August 14, 1984
JPN-84-54

Subject: James A. FitzPatrick Nuclear Power Plant
Docket No. 50-333
Mark I Program

Response to Open Items from NRC/BNL/NYPA/TES Meeting

T-QUENCHER LOCATIONS - FITZPATRICK

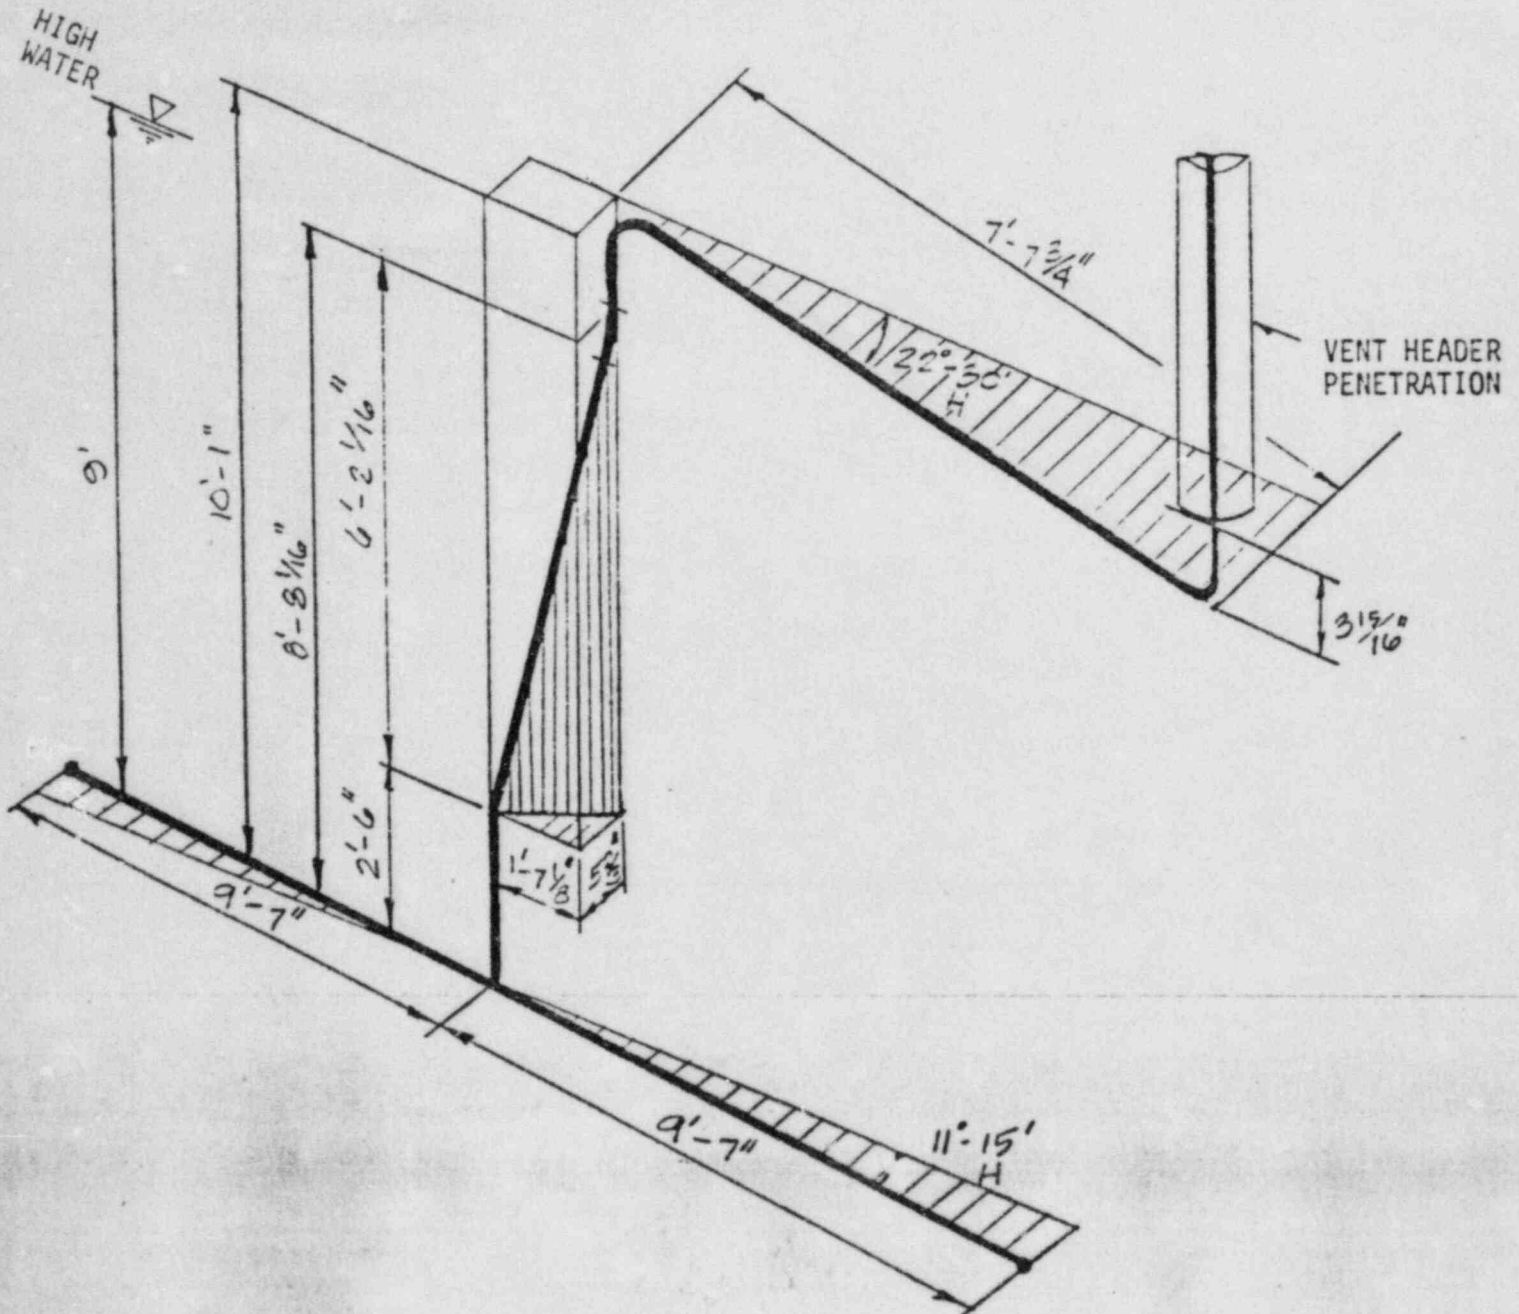
Item 1 Identify SRV lines which provide the ADS function

Response There are seven ADS lines at FitzPatrick. These are lines A, B, C, D, E, G, H. They are shown on the attached sketch.

TYPICAL FITZPATRICK SRV LINE ROUTING IN POOL

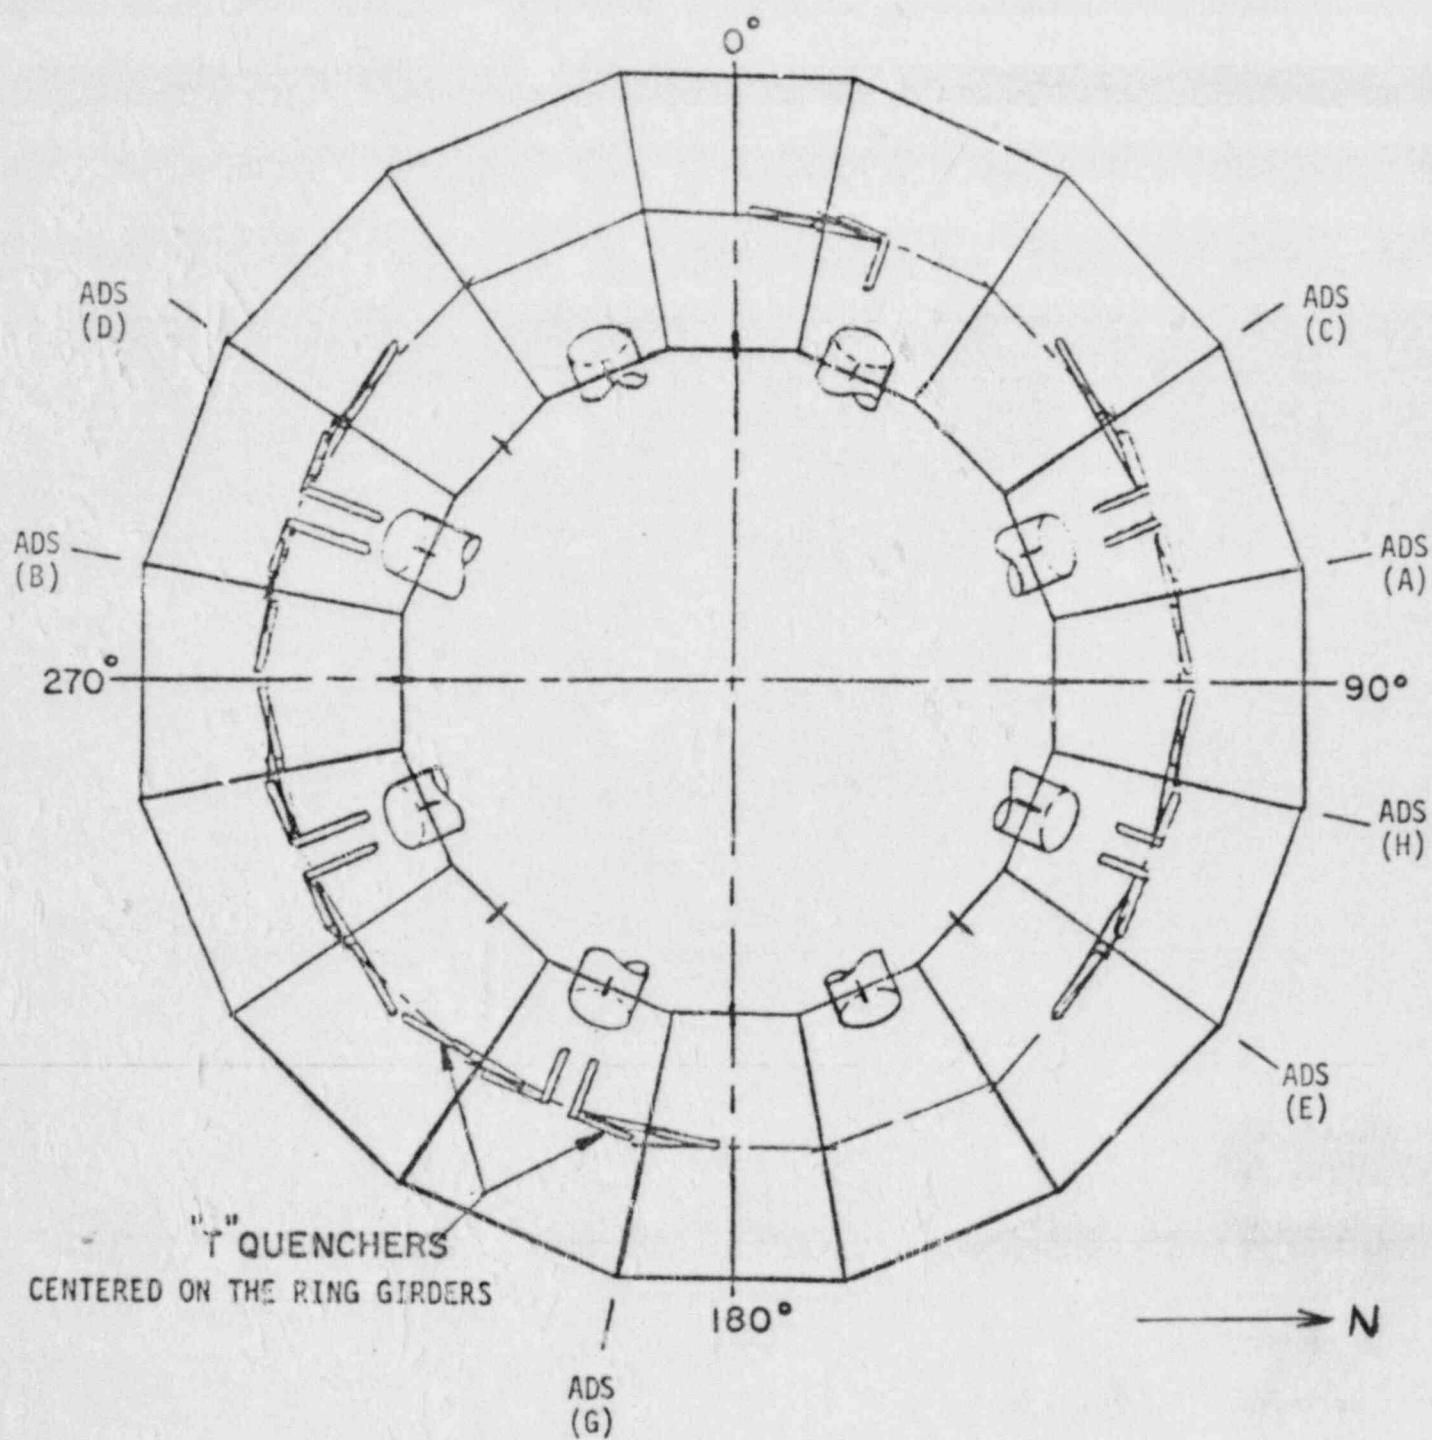
Item 3 Provide a corrected figure showing SRV line entry angle into the pool (part of presentation to Item D-3)

Response The corrected figure is attached. The figure included in the handout had an error in location of one dimension.

This figure was included only to show entry angle and did not effect any other part of the presentation.
